City Planning's 2026 Proposed East Venice Community Plan

Presentation by the VNC's Community Plan/Local Coastal Program
Ad Hoc Committee

2026 City Planning Proposal for Low Residential

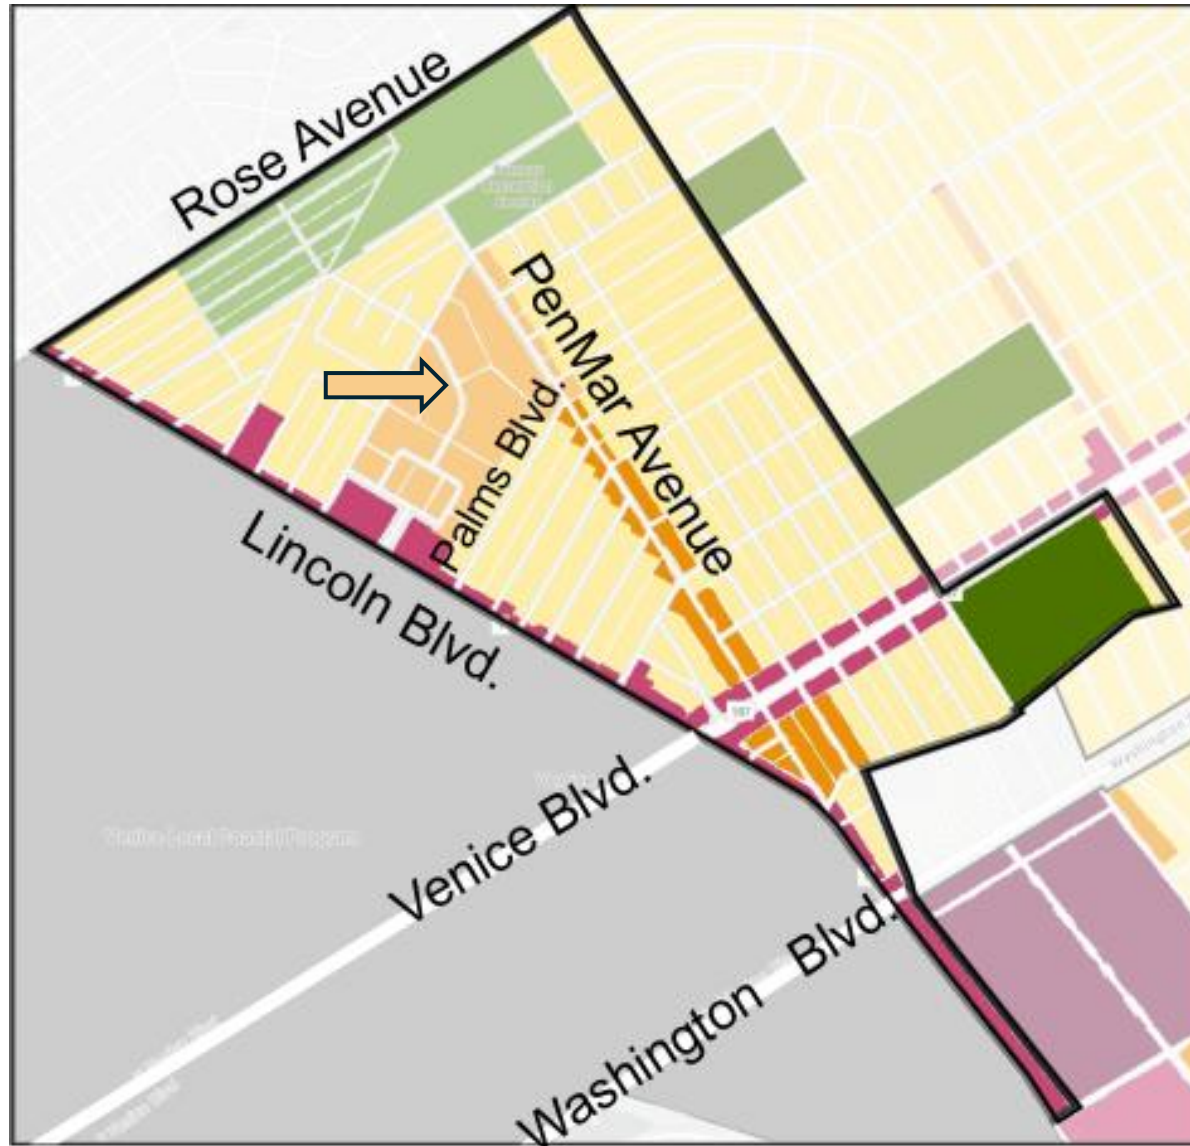
Comparison of VNC 2024 vs. City Planning 2026 ↓	Density - DU/lot (excluding ADUs)	Maximum Height: Tier 1 Bonus Tier 2 Bonus	Floor Area Ratio (FAR): Tier 1 Bonus Tier 2 Bonus
VNC Recommendation (2024)	1 DU/Lot	2 stories, ≤30' no bonuses	0.45 - 0.55 no bonuses
City Planning Proposed (2026)	1 DU/lot	33', no bonuses	0.45 - 0.57 no bonuses

2026 City Planning Proposal for Lincoln Place

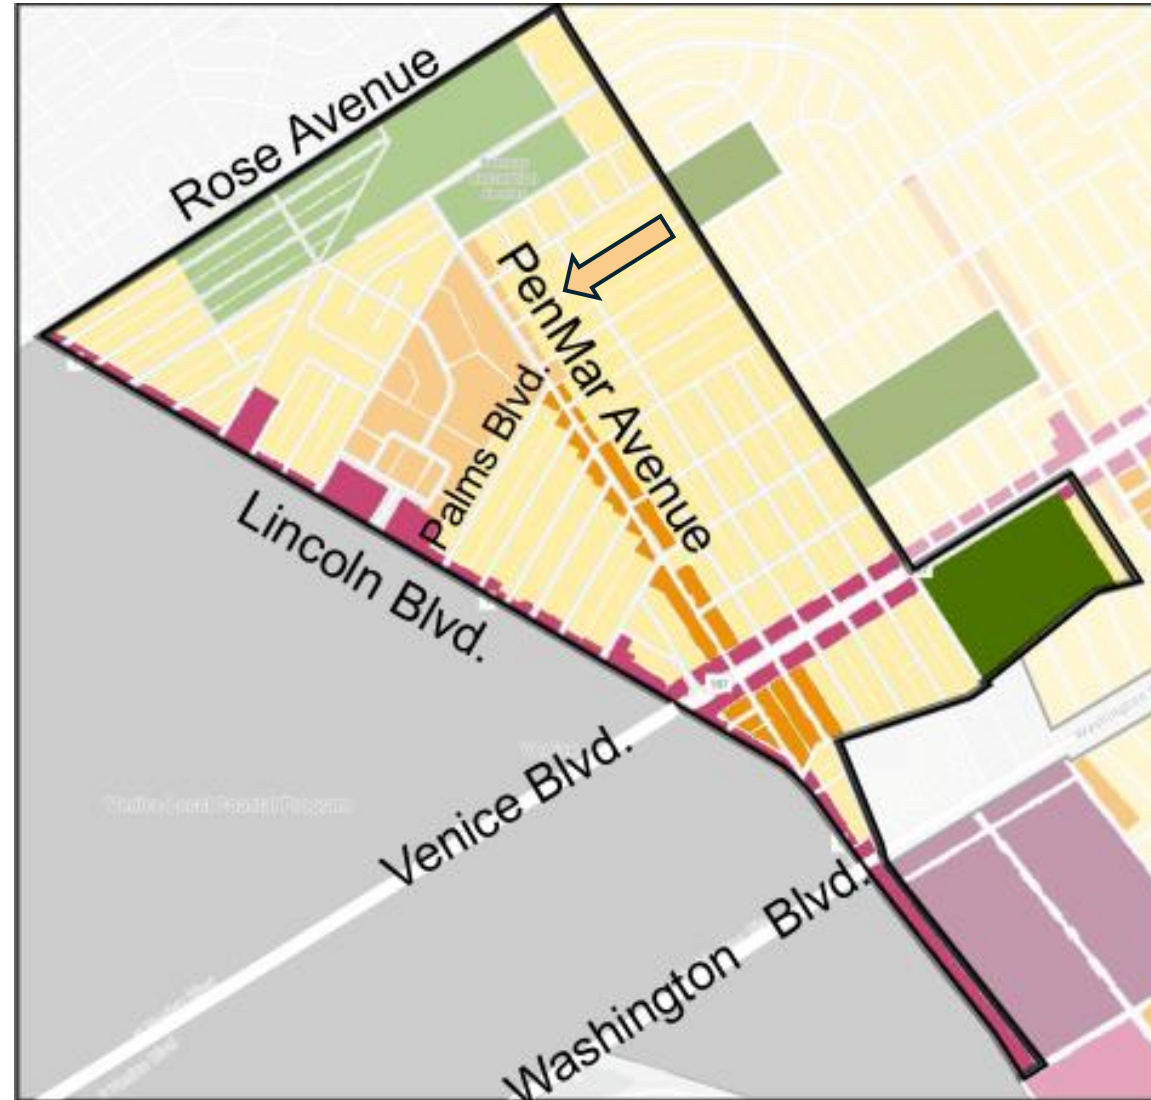
Comparison of VNC 2024 vs. City Planning 2026 ↓	Density - DU/Lot (excluding ADUs)	Maximum Height: Tier 1 Bonus Tier 2 Bonus	Floor Area Ratio (FAR): Tier 1 Bonus Tier 2 Bonus
VNC Recommendation (2024)	1 DU/1,500 SF of lot	2 stories, ≤25' no bonuses	0.9 (1.0 with bonus)
City Planning Proposed (2026)	1 DU/1,500 SF of lot	3 stories (Tier 1 bonus = 4)	1.5 (Tier 1 bonus = 2.0)

2026 City Planning Proposal for Low Residential

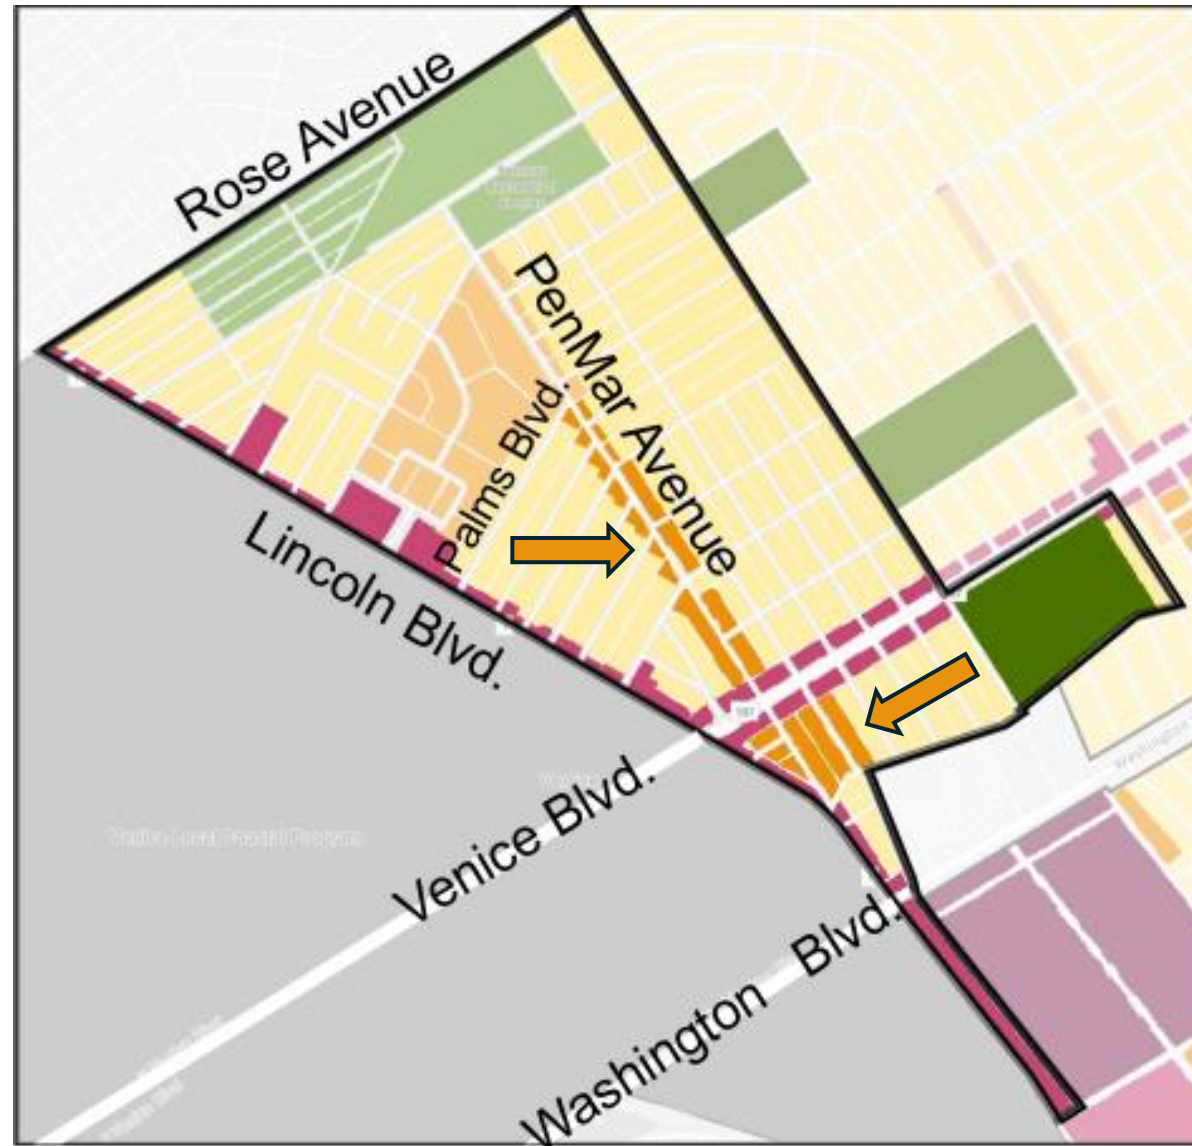
Comparison of VNC 2024 vs. City Planning 2026 ↓	Density - DU/Lot (excluding ADUs)	Maximum Height: Tier 1 Bonus Tier 2 Bonus	Floor Area Ratio (FAR): Tier 1 Bonus Tier 2 Bonus
VNC Recommendation (2024)	1 DU/1,500-3,000 SF of lot	2 stories, ≤25' no bonuses	0.9 (1.0 with bonus)
City Planning Proposed (2026)	1 DU/2,000 SF of lot	3 stories (no bonuses)	1.0 (Tier 1 bonus = 1.5)

2026 City Planning Proposal for Medium Residential

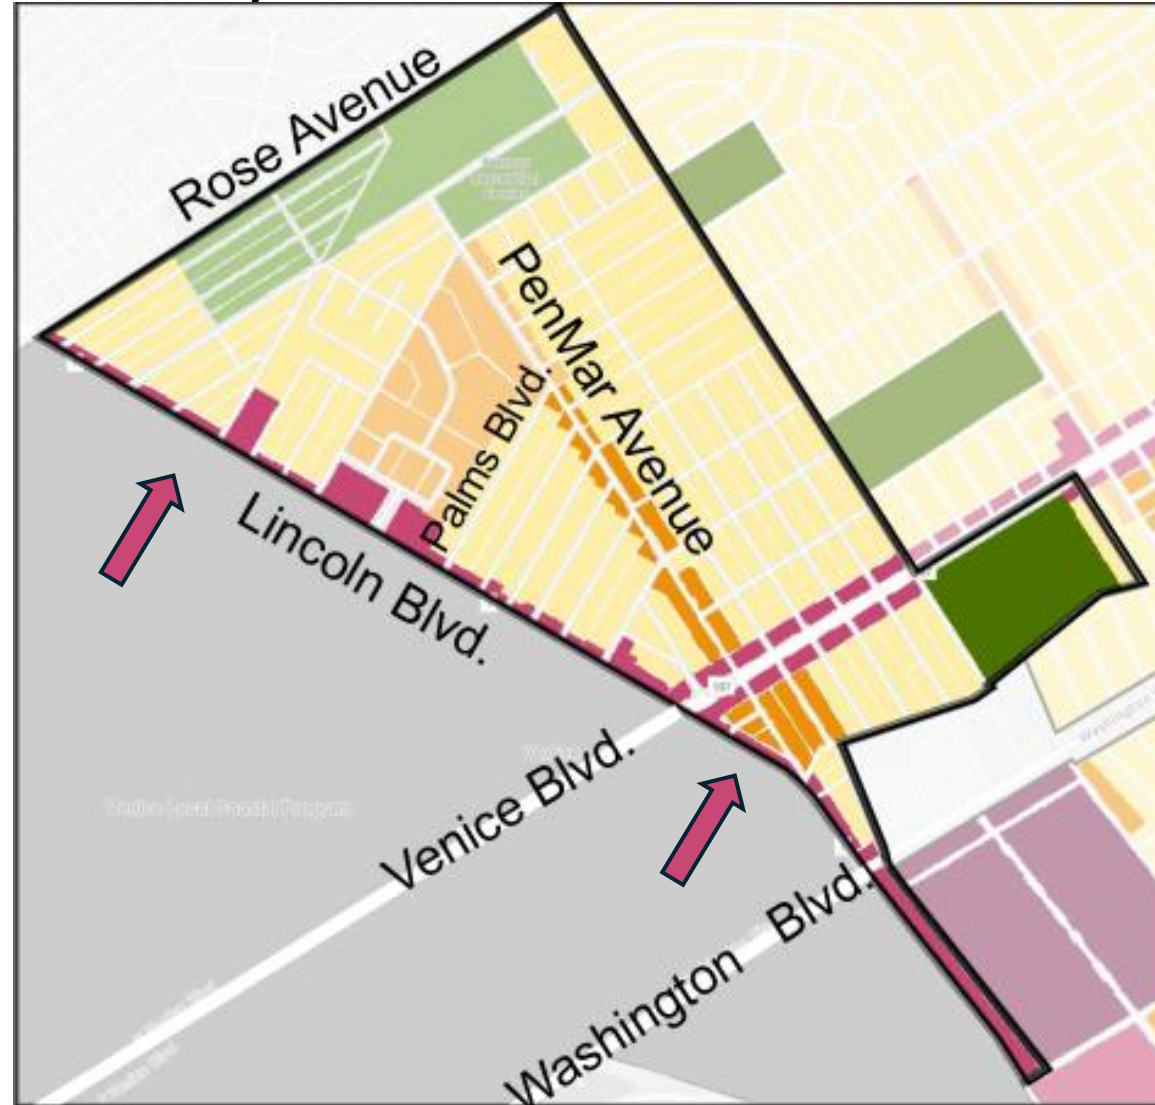
Comparison of VNC 2024 vs. City Planning 2026 ↓	Density - DU/Lot (excluding ADUs)	Maximum Height: Tier 1 Bonus Tier 2 Bonus	Floor Area Ratio (FAR): Tier 1 Bonus Tier 2 Bonus
VNC Recommendation (2024)	1 DU/1,500 SF of lot and 2 DU/lot	2 stories, ≤25' no bonuses	0.75 (1.0 bonus, exc. Walnut)
City Planning Proposed (2026)	1 DU/1,000 SF of lot, 1DU/3,000 SF of lot in places	3 floors (Tier 1 bonus = 7) (Tier 2 bonus = 8)	1.5 (Tier 1 bonus = 4.5) (Tier 2 bonus = 5.0)

2026 City Planning Proposal for Community Center

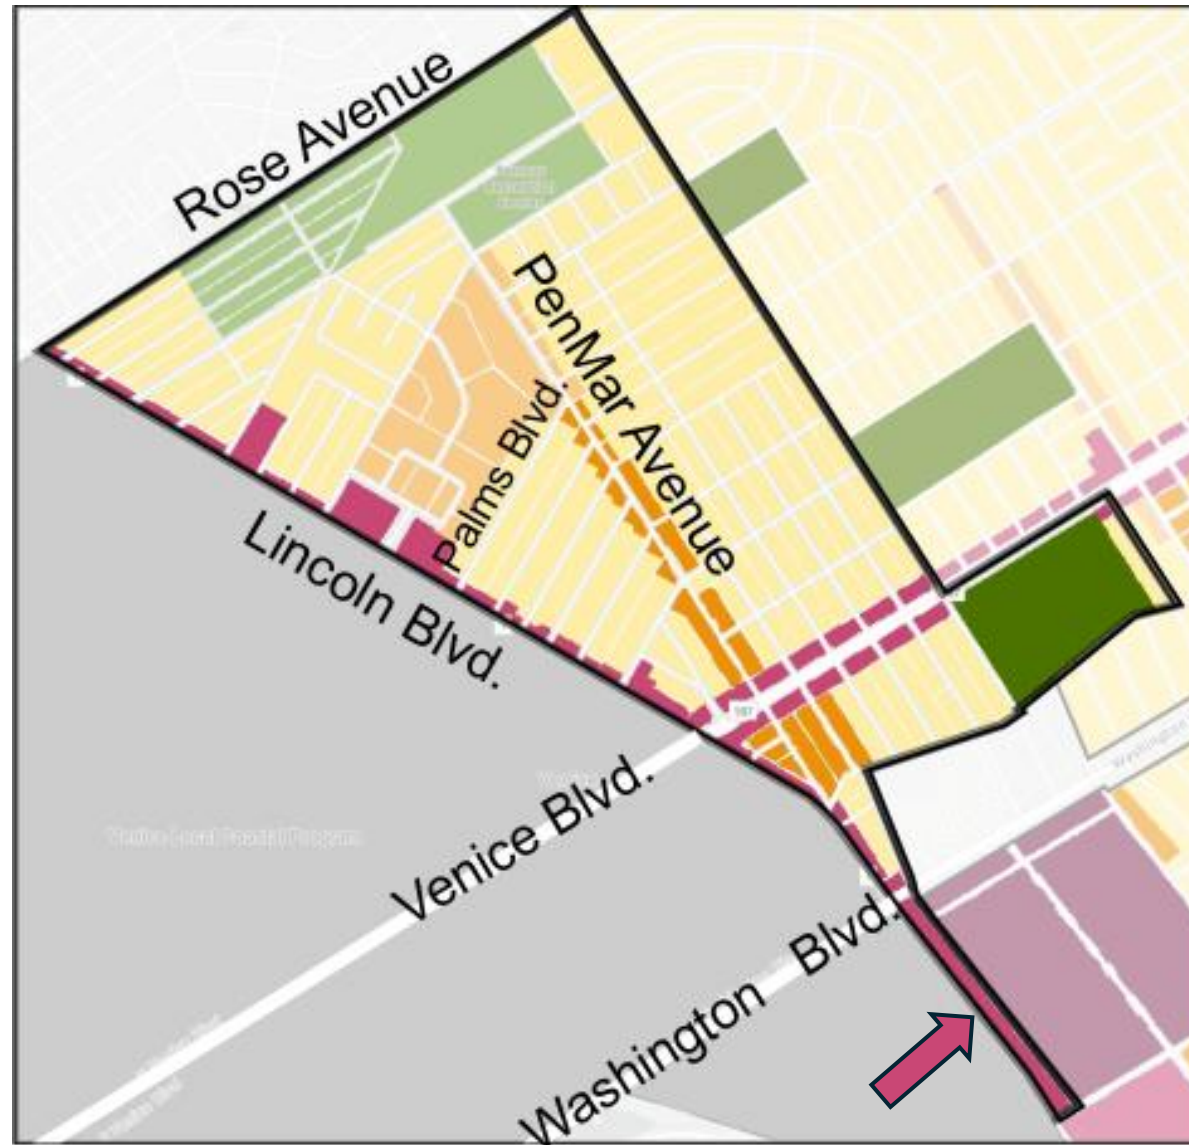
Comparison of VNC 2024 vs. City Planning 2026 ↓	Density - DU/Lot (excluding ADUs)	Maximum Height: Tier 1 Bonus Tier 2 Bonus	Floor Area Ratio (FAR): Tier 1 Bonus Tier 2 Bonus
VNC Recommendation (2024)	800SF/DU	3 stories, ≤33' (5 stories, ≤55' with bonus)	1.0 (1.5 with bonus)
City Planning Proposed (2026)	1 DU/400 SF of lot	3 stories (Tier 1 bonus = 6)	1.5 (Tier 1 bonus = 4.0)
